**CONCEPTUAL SERVICING AND
STORMWATER MANAGEMENT REPORT**

3200 REID'S LANE SUBDIVISION

**Re: Conceptual Servicing and Stormwater Management Report
Reid's Lane Subdivision
Response to Comments
Our File No.: 119089**

Re: Draft Plan of Subdivision Application – 3200 Reid’s Lane (3rd review)

LOCATION
CITY OF OTTAWA
REID'S LANE SUBDIVISION

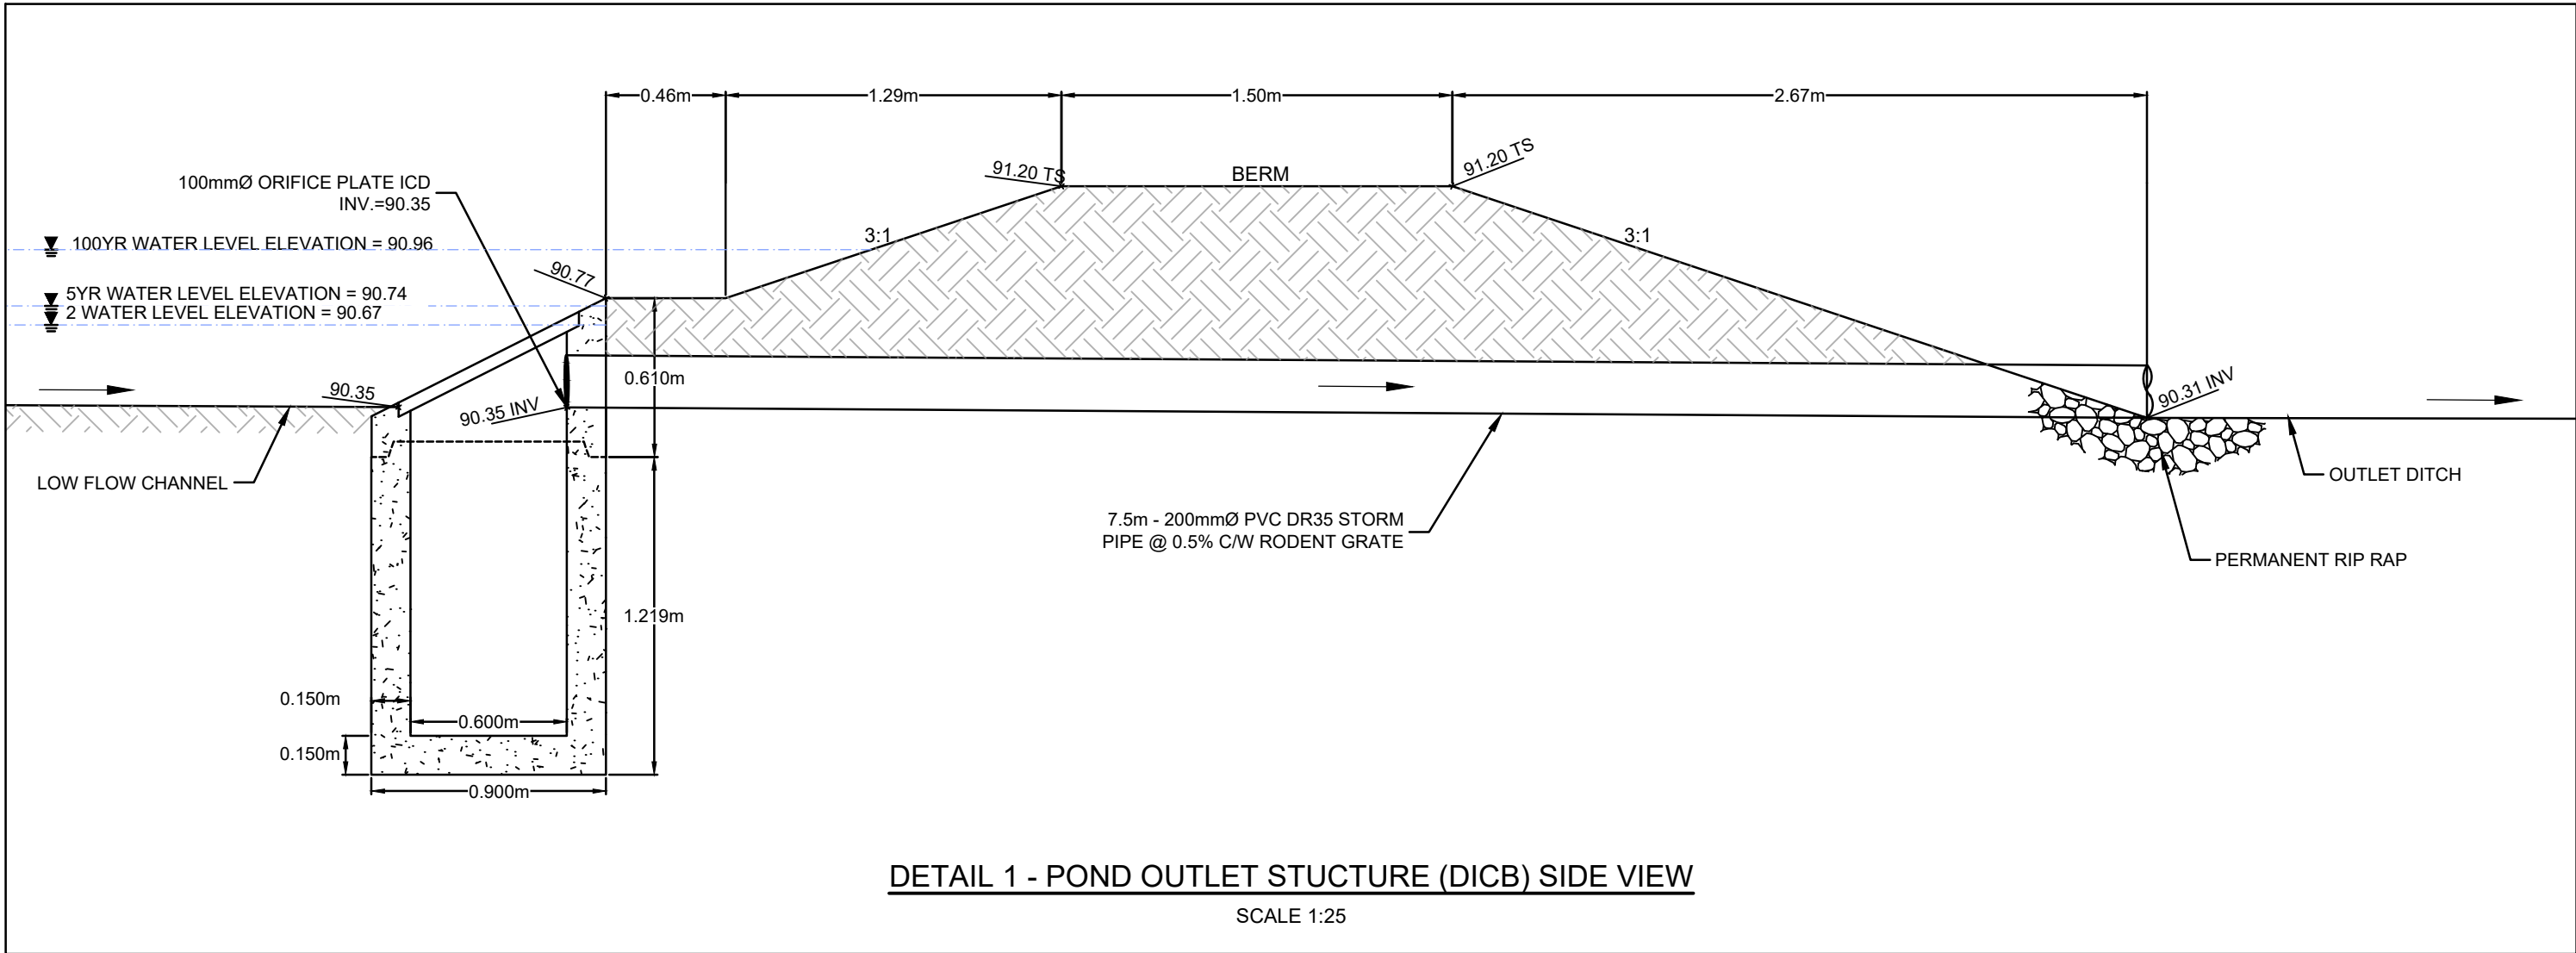
10. The detail of the inlet to the pond is required.
11. The location of the pond against the property line would not allow an industrial lawn mower to cut grass between the property line and the slope of the pond.
12. The outlet weir with the 0.09m wide is susceptible to plugging by debris.
13. Please assure that the pond will function as a dry SW facility and have positive outlet and will not be soggy. In addition, please provide us with calculations that the pond will not back up to the adjacent lots at the Lombardy Way cul-de-sac.
14. Further comments provided by the City's Stormwater Management Modelling Review Unit are enclosed.

The location of the dry pond is shown on the Preliminary Grading & Site Servicing Plan (**119089-PGR**). The details on the design of the dry pond and flow control structure are provided on the Stormwater Management Pond Facility plans (**119089-SWMF** and **119089-SWMF1**).
